Access Compliance Report Public Rights-of-Way (Curb Ramps)

Main Street: JUDY_ANNE_LN		Cross Street: CASTLEGATE_LN		Location:	NE
ADA ID: RPRK220125135000	Ramp Type: Type 4 - Parallel	Initial Pass/Fail: Fail	Overall Compliance: No	Severity Score:	15
Codes/Mitigation Info/Possible Solution			Field Measurements/Component Compliance

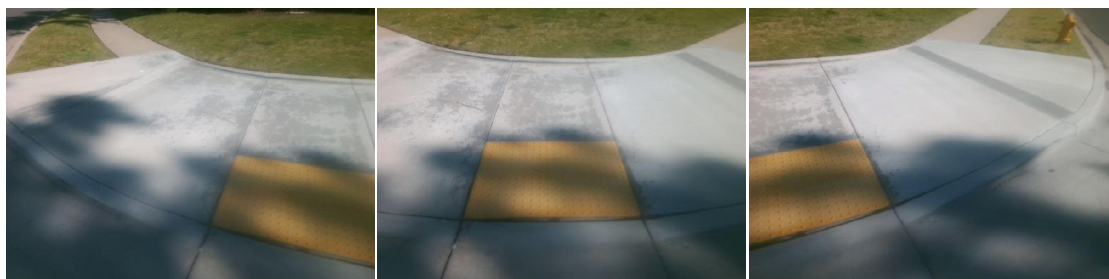
Compliance	Description	Data	Compliance	Description	Data
N/A	Ramp Length LT (in)	76	N/A	Ramp Length RT (in)	79
Yes	Ramp Width LT (in)	130	Yes	Ramp Width RT (in)	130
Yes	Ramp Run Slope LT (%)	4.7	Yes	Ramp Run Slope RT (%)	4.3
No	Ramp Cross Slope LT (%)	5.5	No	Ramp Cross Slope RT (%)	4.6
N/A	Landing Present	N/A	N/A	DWS Provided	N/A
N/A	Landing Length (in)	N/A	N/A	DWS Contrast	N/A
N/A	Landing Width (in)	N/A	N/A	DWS Length (in)	N/A
N/A	Landing Run Slope (%)	N/A	N/A	DWS Full Width	N/A
N/A	Landing Cross Slope (%)	N/A		DWS Offset Type	N/A
N/A	Landing Movement Obstructed?	N/A	N/A	DWS Offset Left (in)	N/A
	Landing Movement Type	N/A	N/A	DWS Offset Right (in)	N/A
N/A	Landing Shared	N/A			
N/A	Clear Space	Yes			
N/A	Clear Space To Crosswalk (in)	N/A			
N/A	Marked Crosswalk 1	No	N/A	Marked Crosswalk 2	No
	Crossing 1 Direction	W		Crossing 2 Direction	S
	Marked Crosswalk 1 Width (in)	N/A		Marked Crosswalk 2 Width (in)	N/A

Remove & Replace Curb Ramp With Two New Directional Ramps or Equivalent.

R304.5.3, STD 1115
